**SUNSHINE NOTICE  
BOROUGH OF BERGENFIELD  
ZONING BOARD OF ADJUSTMENT  
SPECIAL MEETING  
FEBRUARY 24, 2021 8:00PM  
TELECONFERENCE MEETING VIA ZOOM**

**Application:** 145 West Main Street, LLC  
145 West Main Street  
Change of use to a multi-family dwelling R-5 zone to RM zone  
Carried over from January 11, 2021 meeting.

**Borough of Bergenfield**  
**Site Plan Committee Minutes**  
**February 10, 2020**

**145 West Main Street LLC**

**FIGURE 1 – Crash Data  
145 West Main Street**

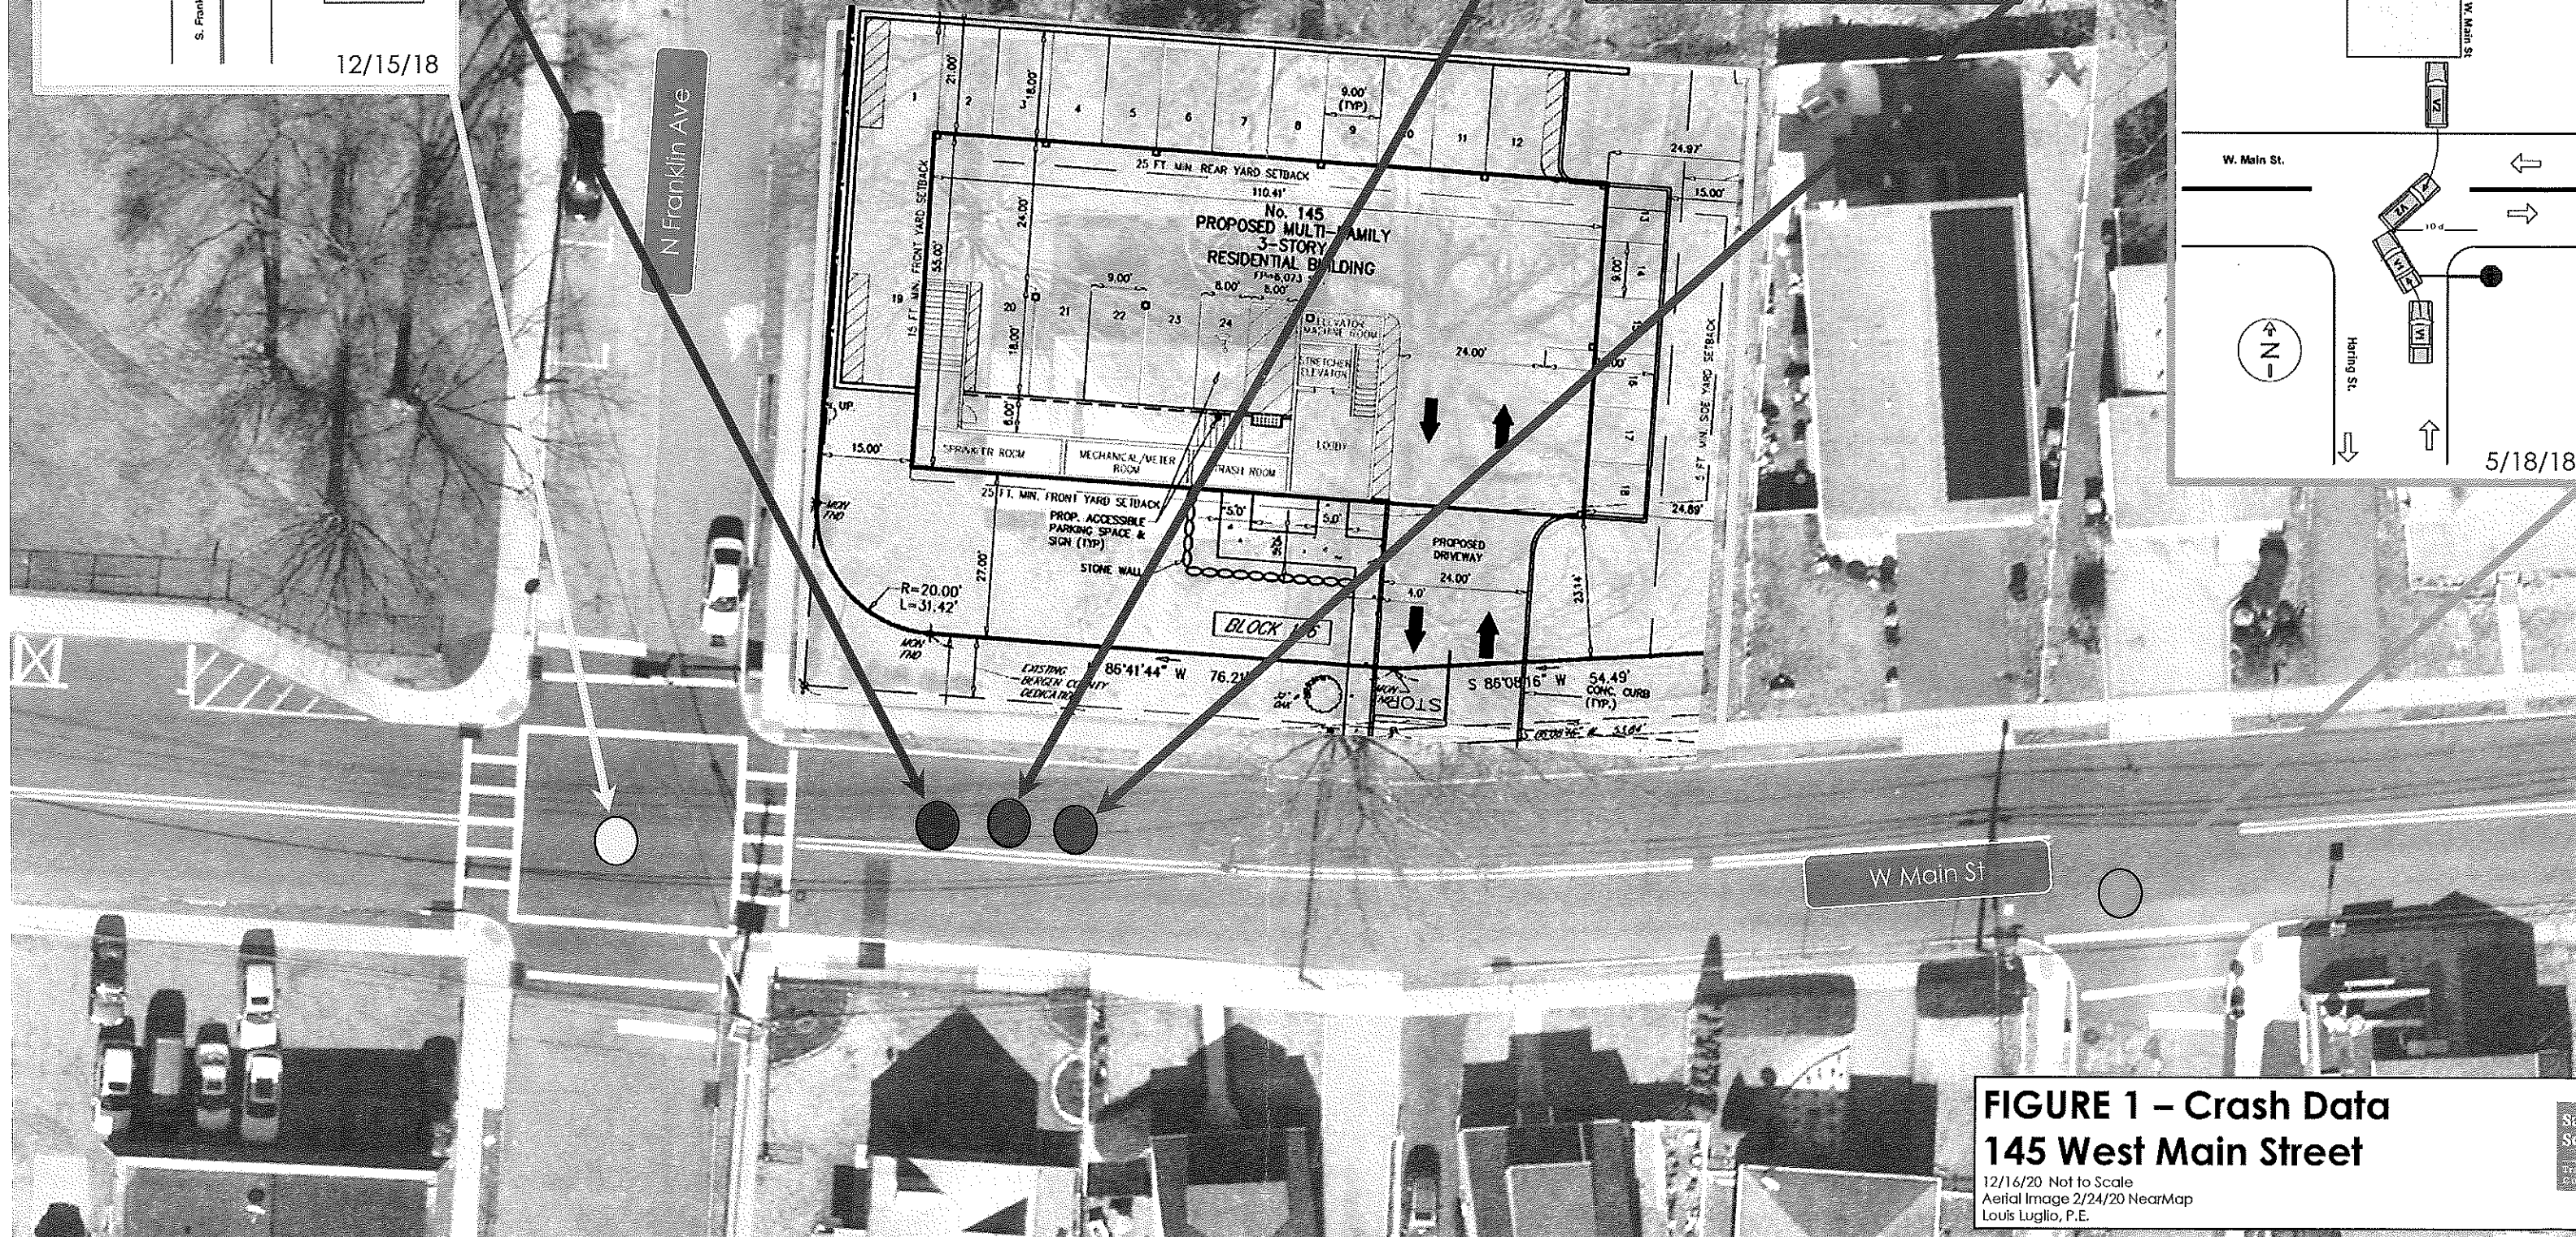
4. **Findings based upon receipt of accident data** - We requested copies of all crash reports along the segment of W. Main Street, between N. Franklin Avenue and Haring Street for the past three years (2019, 2018, and 2017). **FIGURE 1** shows a summary of crash data received. There was a total of six crash reports ranging from intersection to animal interactions. These crash reports do not have any correlation to the proposed driveway along W Main Street.

**FIGURE 1 Driveway Locations  
145 West Main Street**

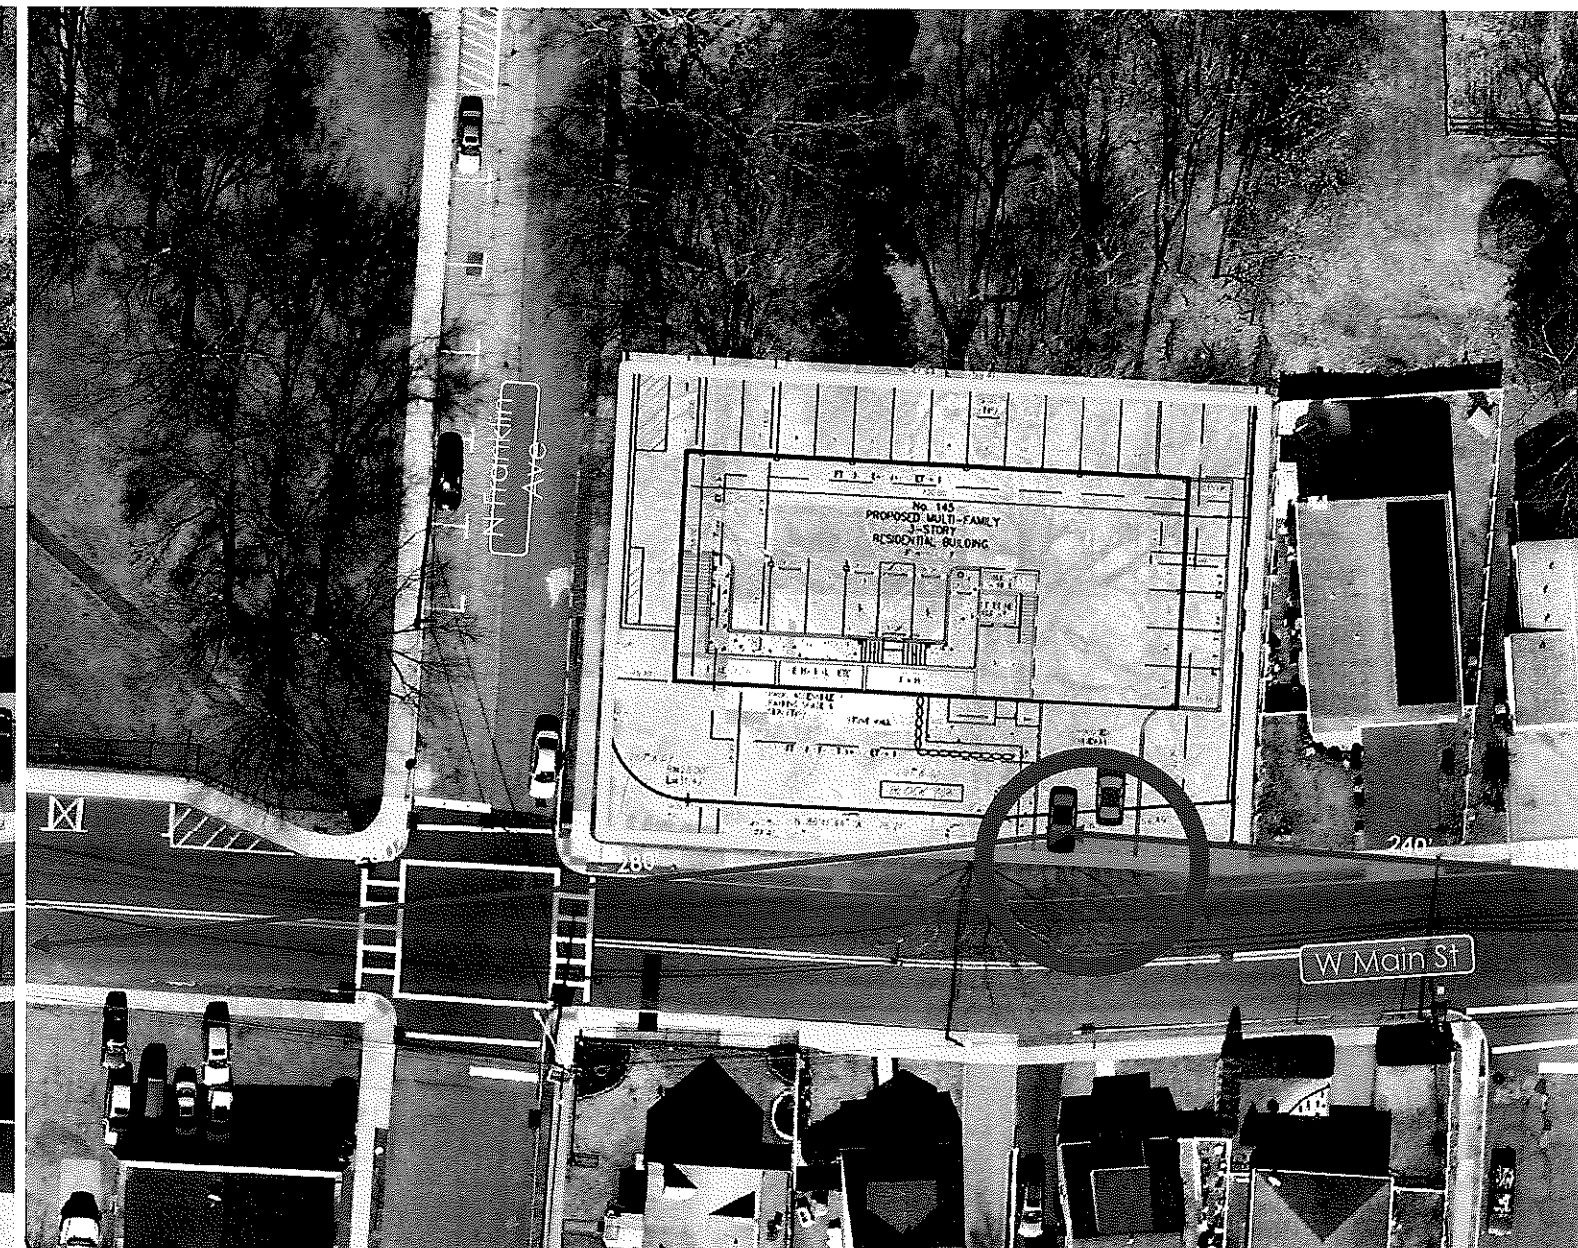
5. **Revised driveway location** – The revised proposed driveway location along W Main Street would be safe and efficient. The proposed driveway could provide pedestrian signal heads across the proposed driveway / sidewalk to increase pedestrian safety and awareness. In addition, there also could be prohibitions on left turns in and out of the proposed driveway. The proposed driveway should not be in conflict with existing driveways across W Main Street as the roadway provides for sufficient width.
